TECHNICAL INFORMATION

No: 76/20/03/NAS
 Ref:
 Issue: 1
 Date: 10/31/03

Interior Squeaks and Rattles

Discovery Series II (LT)

Figure 1

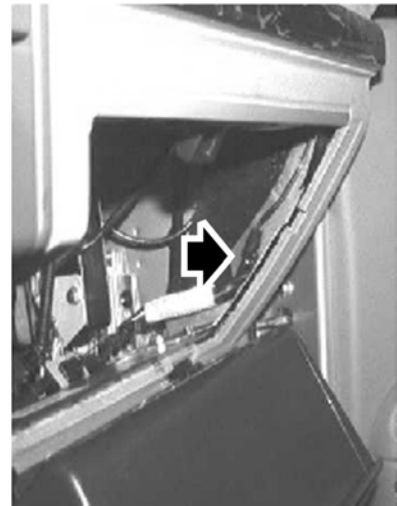
1. Open the glove box, align stops with cutouts in fascia and remove the glove box.
2. Ensure the light harness clip is fitted to appropriate hole in fascia frame (Arrowed in Figure 1).
3. Ensure the aerial coaxial lead is fitted as shown ('A' in Figure 2).
4. Ensure the airbag harness is fitted in the 'Y' frame ('B' in Figure 2).
5. Raise the glove box, align stops with cut outs in fascia and close the glove box.

Figure 4

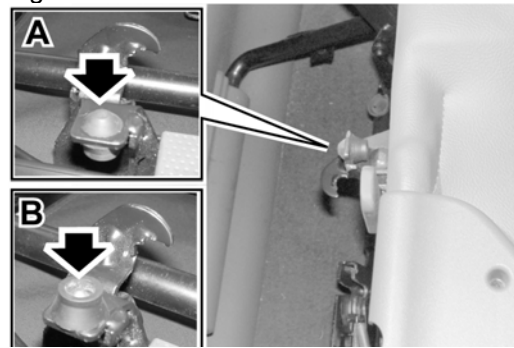
1. Release the 3rd row seat from the stowed position.
2. Remove the rubber buffer and refit in reversed position (from 'A' to 'B' in Figure 4)
3. Remove backing from tape (STC3118K) and fit pad to the top and the underside of the hook on seat frame (See Figure 5).
4. Fully deploy the seat and apply Krytox to seat piping (Arrowed in Figure 6).
5. Stow seat.
6. Repeat procedure for the other side.

Figure 7

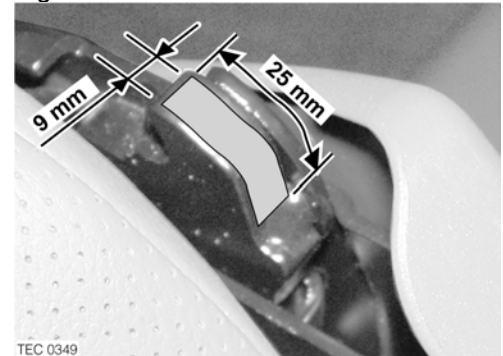
1. Fold the LH and RH rear seat squabs forward.
2. Apply Krytox to the upper area on the LH side of the LH rear seat squab.
3. Cut two velour pads (STC3118K) to the dimensions detailed in Figure 7.
4. Remove backing from the velour pads and install one pad to the LH seat cam ('A' in Figure 8) and one pad to the RH seat cam ('B' Figure 8).
5. Secure seat squab into fixed position.
6. Lower center armrest and apply Krytox to areas between armrest and seat bolsters (Figure 9).
7. Fold center armrest back into position.

Figure 9

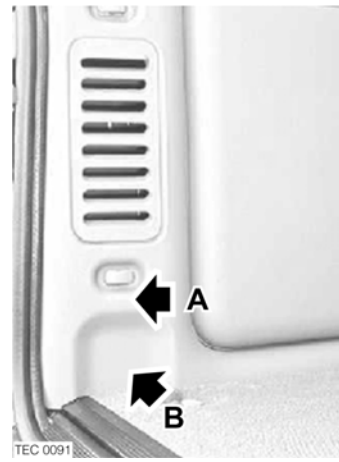
1. Check for slight discolouration on the rear quarter trim ('A' in Figure 9).
2. Carefully push on the bottom of the rear quarter trim ('B' in Figure 9) to create a clearance gap between the subwoofer and the rear quarter trim.
3. Release six clips securing the tail door aperture upper trim casing and remove the upper trim casing.
4. Remove the backing from the tape (STC3118K).
5. Install the tape to both ends of the trim casing. (Arrowed in Figure 10)
6. Remove two trim studs ('A' in Figure 11) from 'D' post upper trim casing and ease casing away from the glass.
7. Remove backing from velour pad (Available in kit STC4006).
8. Install pad to edge of trim casing ('B' in Figure 11).
9. Install studs to trim casing and secure casing.
10. Install and secure the tail door aperture upper trim casing.

Figure 12

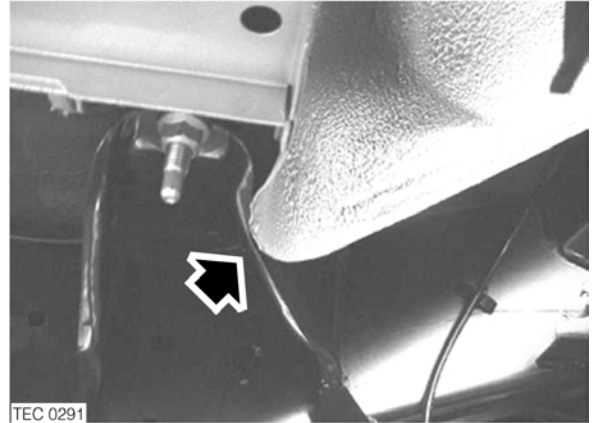
1. Ease the wheel arch away from the chassis outrigger to create a 2-3mm gap (Arrowed in Figure 12).
2. Apply underbody sealer to the damaged area.

Figure 13

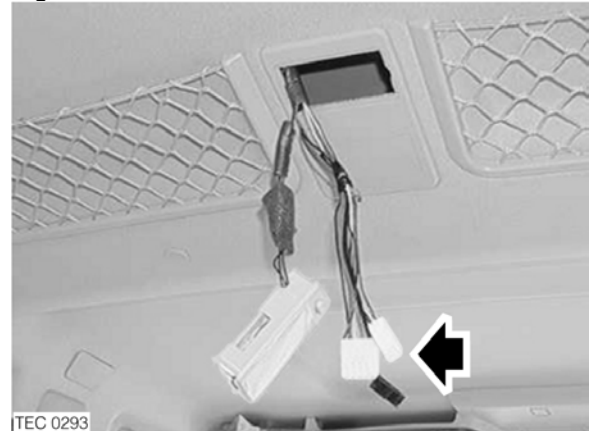
1. Remove the lens from interior lamp.
2. Remove two nuts securing interior lamp to roof.
3. Release the interior lamp from the headlining and locate the unused loose connectors (Figure 13).
4. Wrap all connectors and harnesses with foam tape available in kit STC4006.
5. Position connectors behind the headlining and under the other harness running along the headlining.
6. Install the interior lamp and lens
7. Tap the headlining to verify noise has been eliminated.

Figure 14

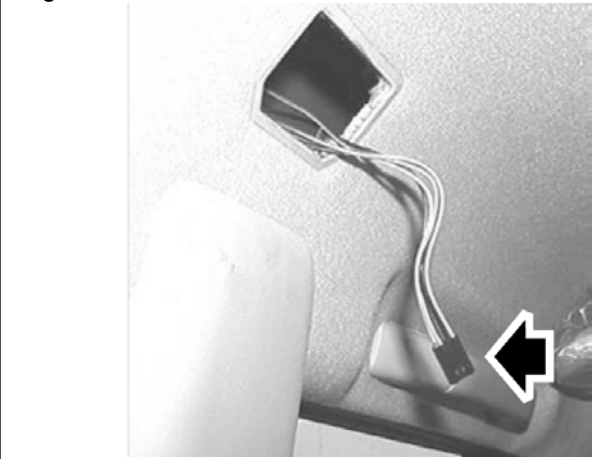
1. Remove the blanking panel from headlining,
2. Locate the unused alarm ultrasonic sensor connector (Arrowed in Figure 14).
3. Wrap foam tape available in kit STC4006 around the connector.
4. Position the connector behind the headlining.
5. Install the blanking panel.

Figure 15

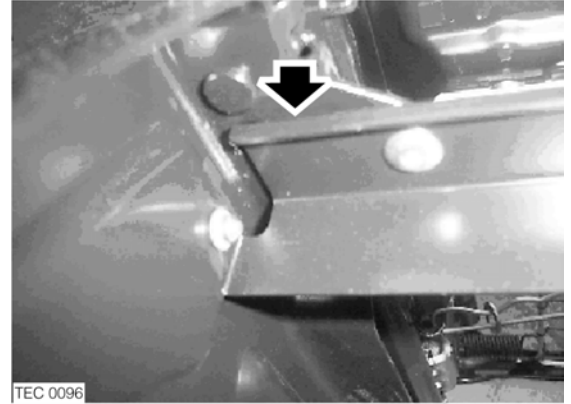
1. Slide seat fully forward.
2. Apply non silicone based grease available in kit HAK000010 to the mating surfaces of the cross member and outboard plinth bracket. (Arrowed in Figure 15)
3. Return seat to original position.

Figure 16

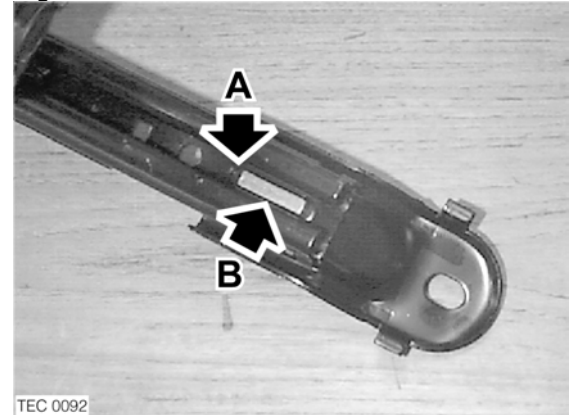
1. Switch ignition to the on position.
2. Slide seat fully forward and apply grease available in kit HAK000010 to both slide end-stops. (Arrowed in Figure 16)
3. Return seat to original position.
4. Switch off ignition.

Figure 17

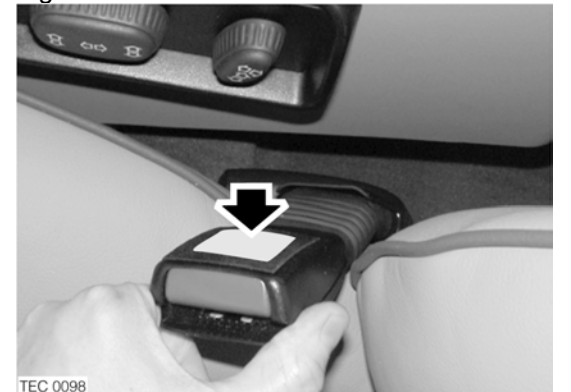
1. Trim and fit velour strips (STC3118K) to the seat belt stalks. (Arrowed in Figure 17)

Figure 19

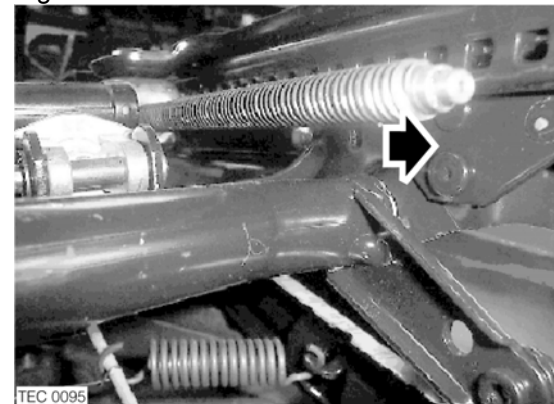
10. Drill out the rivet and open out hole to fit an M6 bolt (arrowed in Figure 19).
 11. Insert a new bolt (supplied in kit HAK000010) with the head of the bolt on the outside of the seat frame, apply a thread lock compound and torque to 14 Nm (xx lbf.in.).
